Value Engineering Study

KY 15 - KY 28 to HADDIX

Item #10-285.00 and #10-286.00

Kentucky Transportation Cabinet (KTC)

**PRELIMINARY PROFILE
ALTERNATE 9**

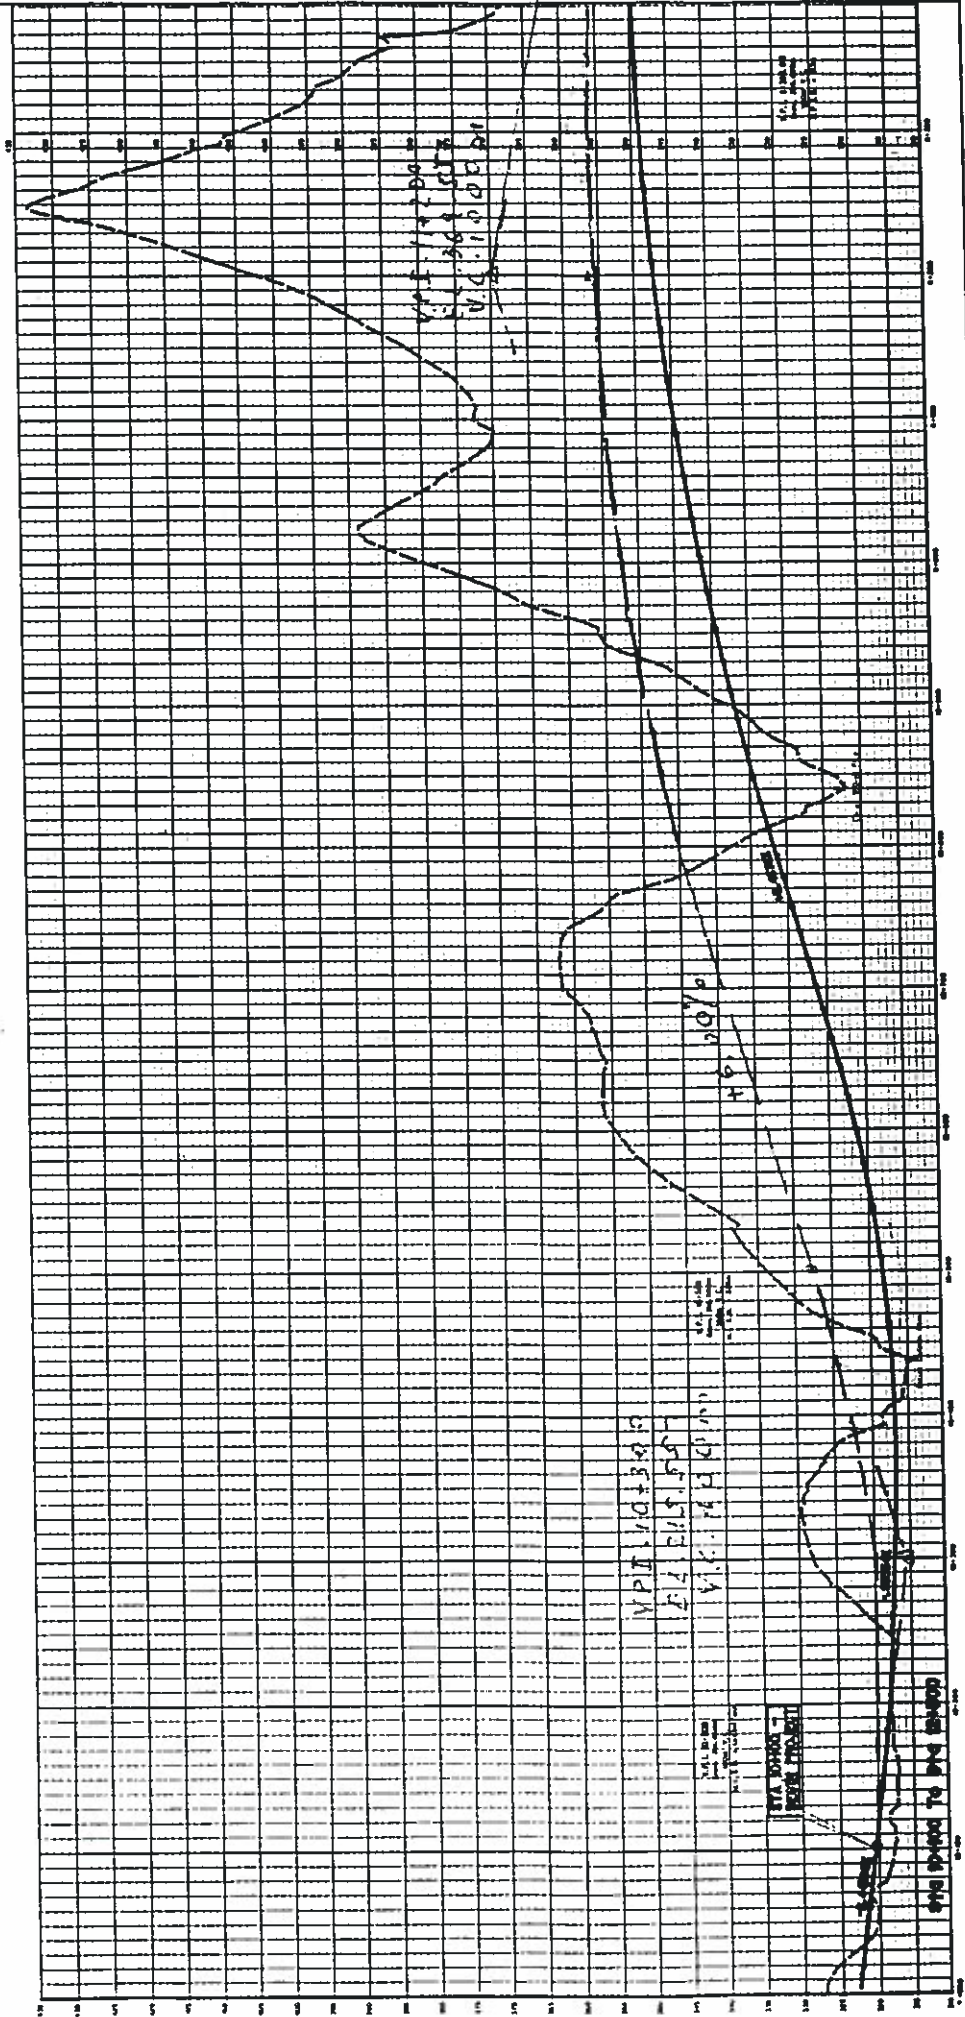
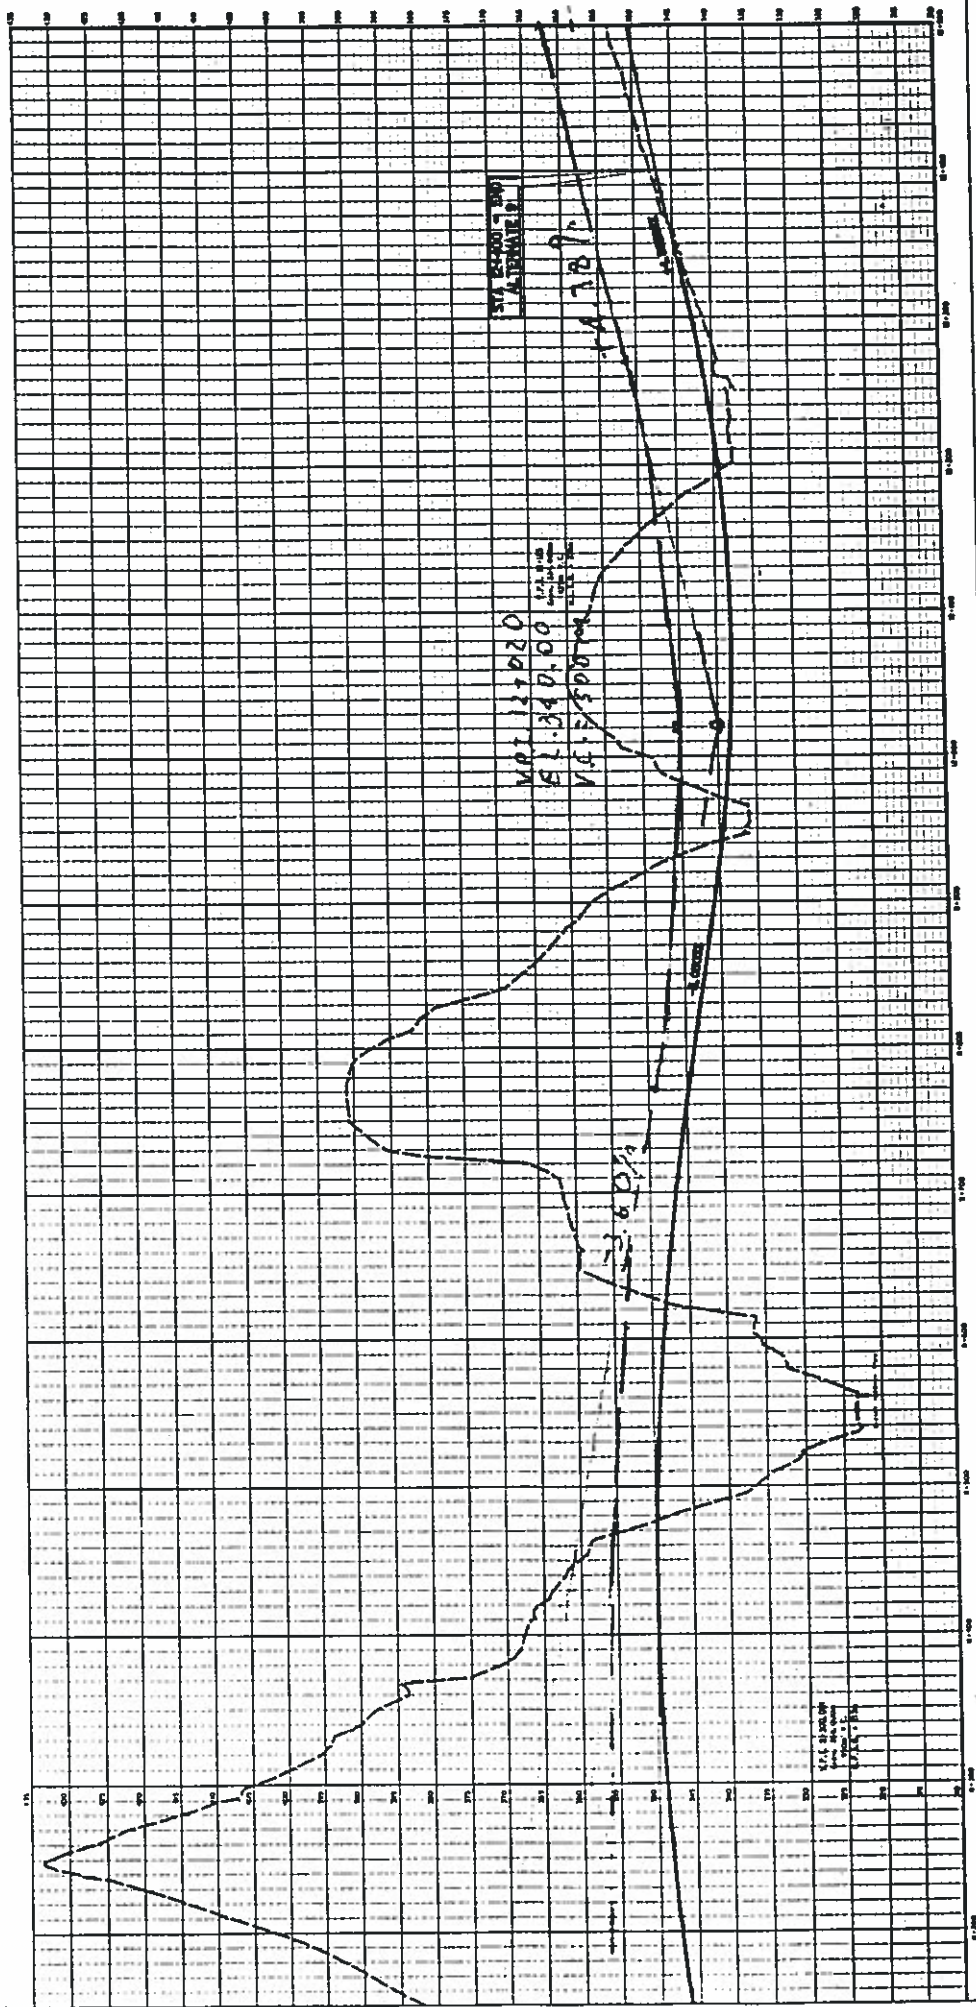
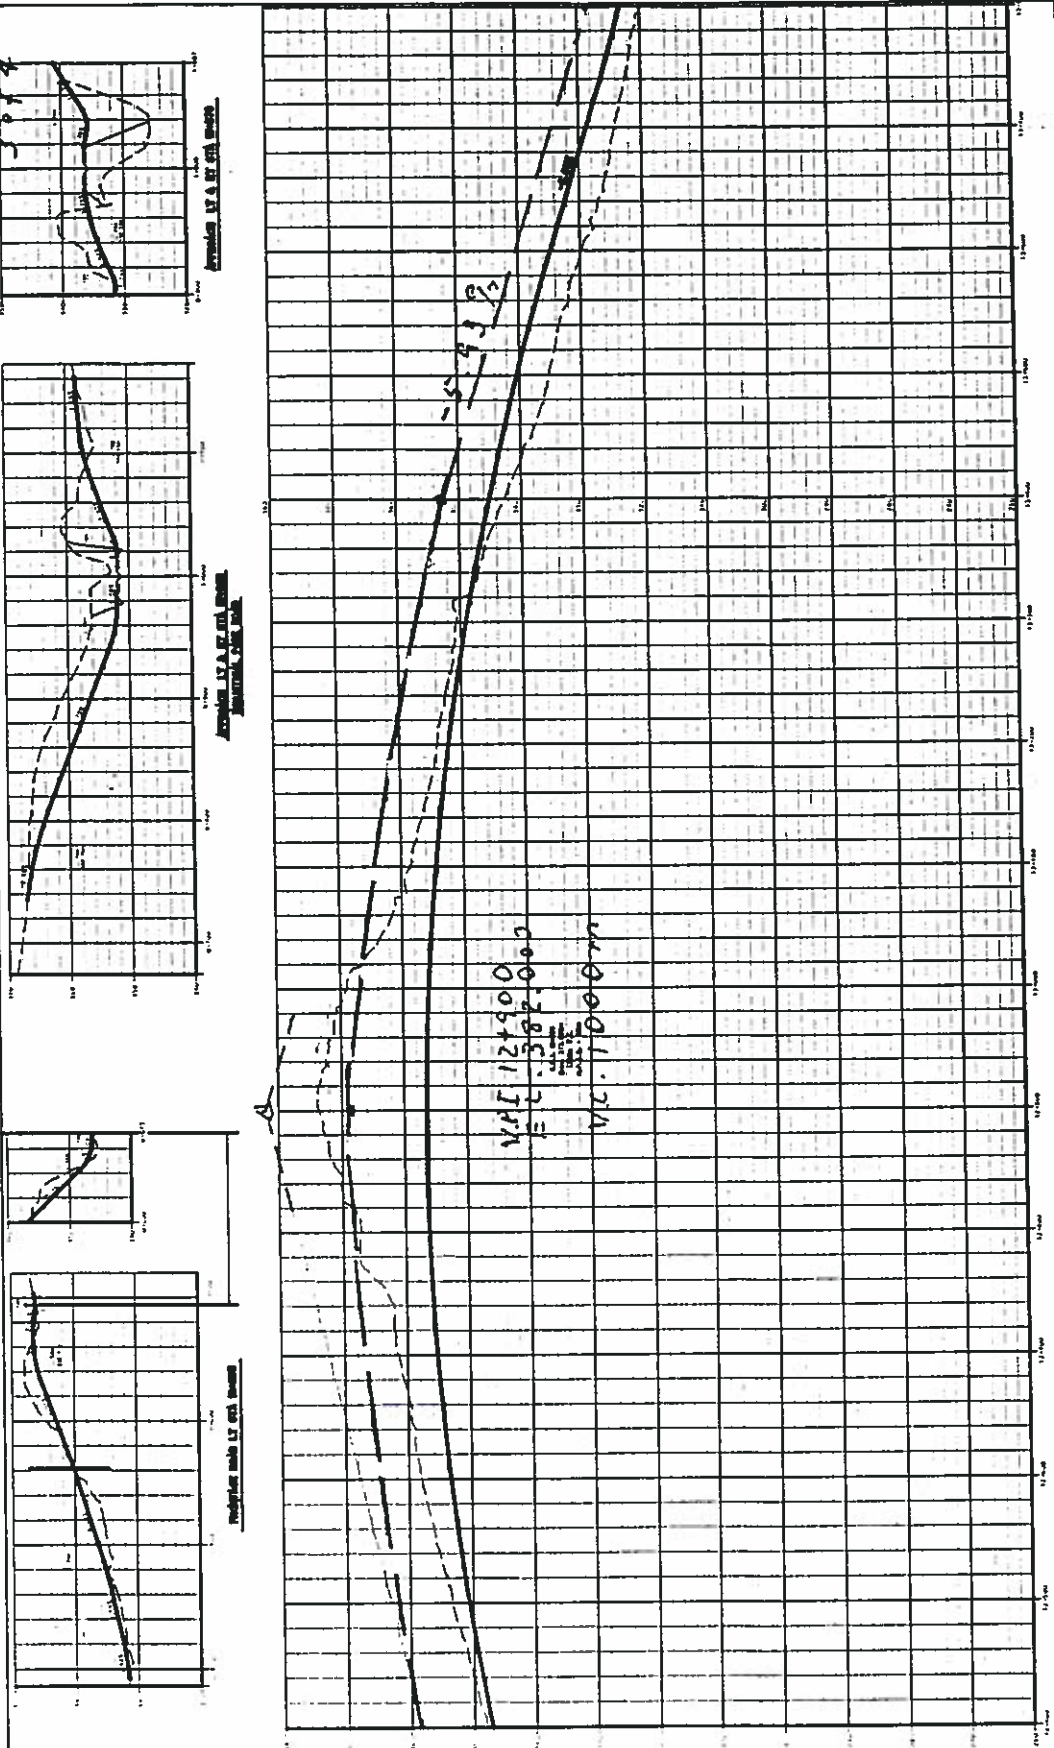
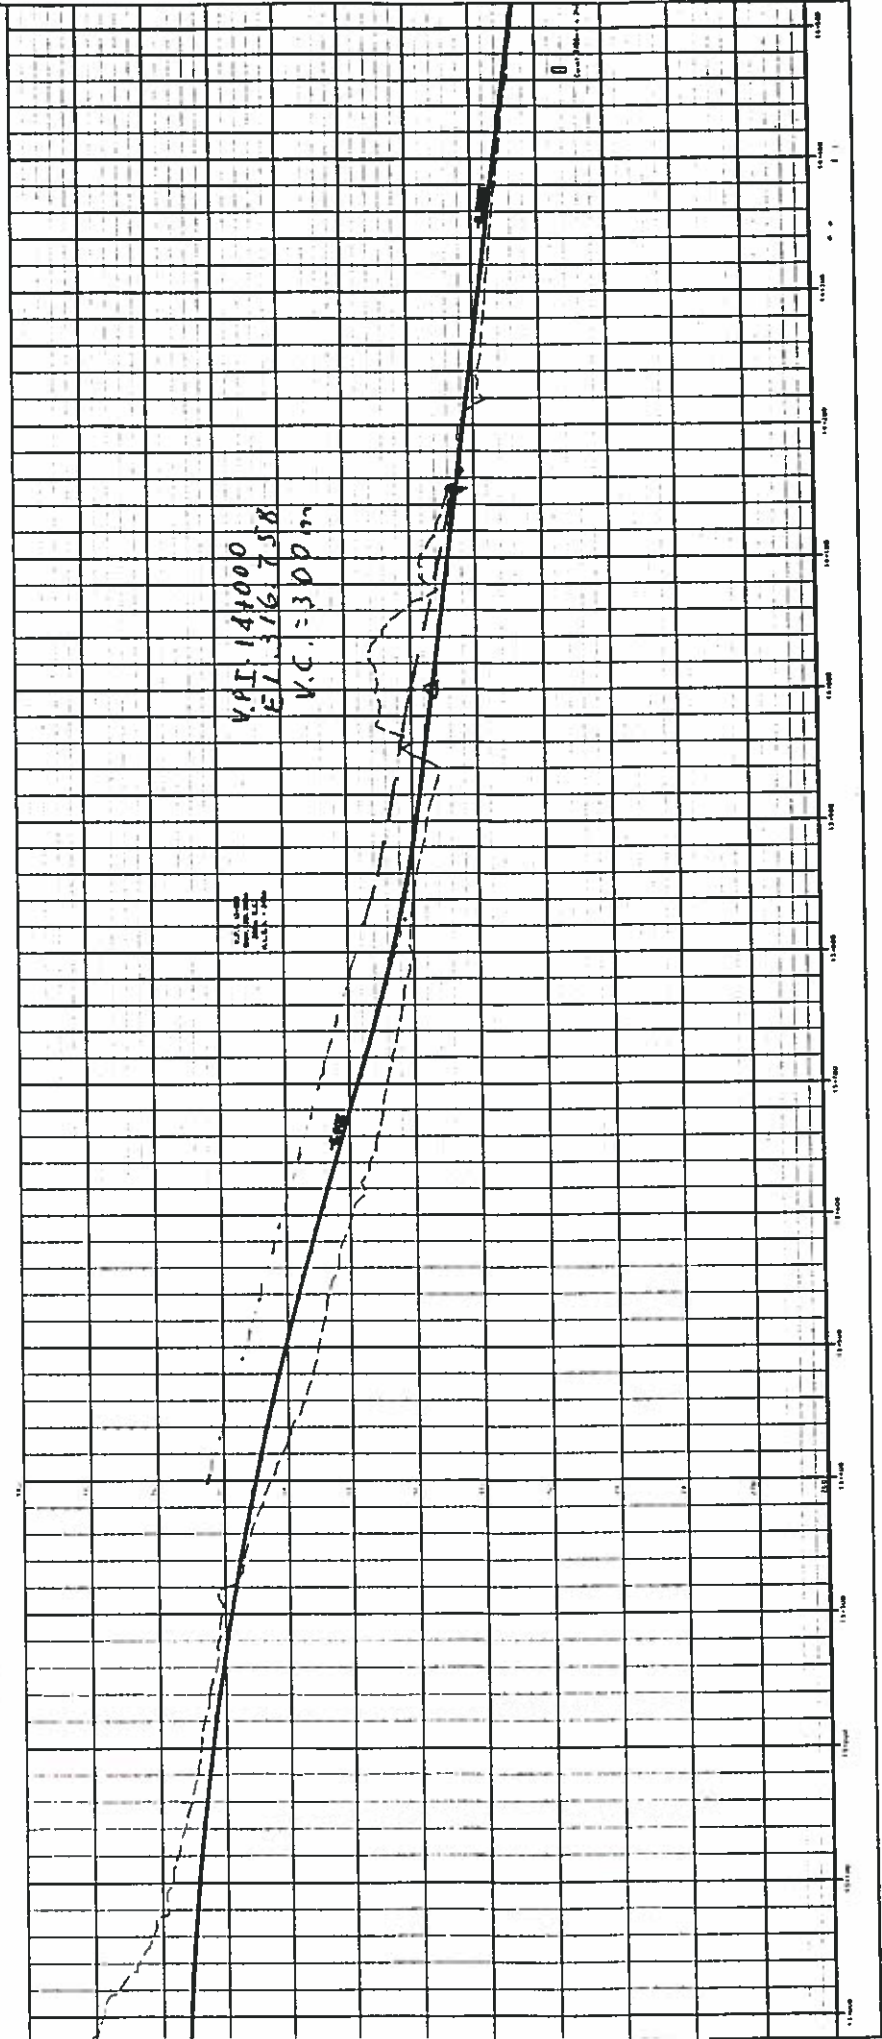
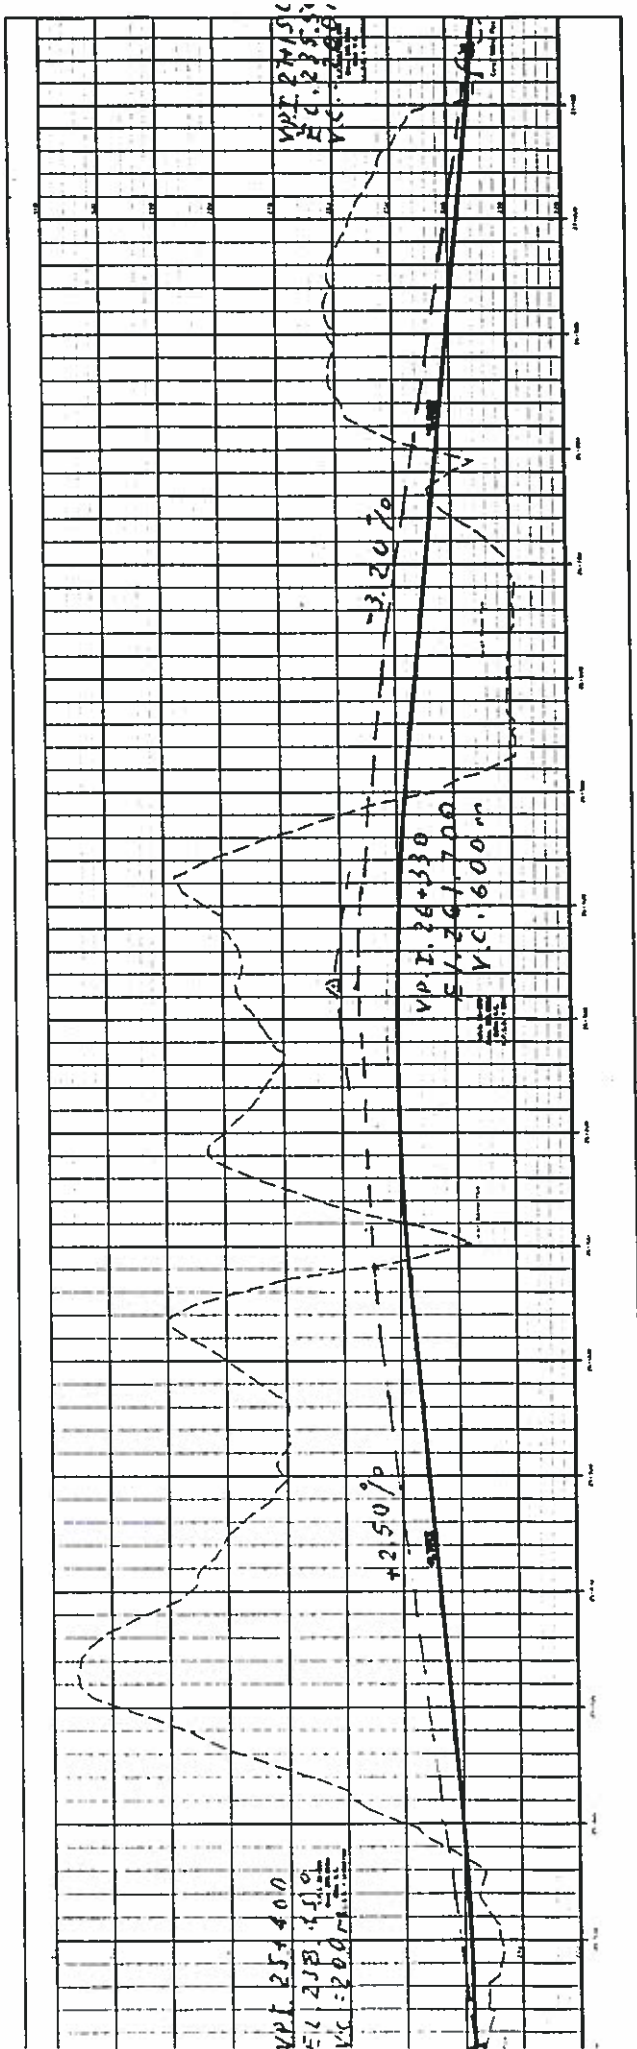
RECOMMENDED CHANGE: The VE Team recommends raising the grades through major cut areas to reduce the amount of roadway excavation quantities. The following areas have been selected because they are not constrained to follow the existing corridor.

Roadway Excavation constitutes 67% of total construction costs in the preliminary estimates. The VE team felt this could be reduced by changing grades in areas of the projects that were not constrained by the vertical alignment of the existing corridor. These areas were defined previously in this report. They are discussed separately below:
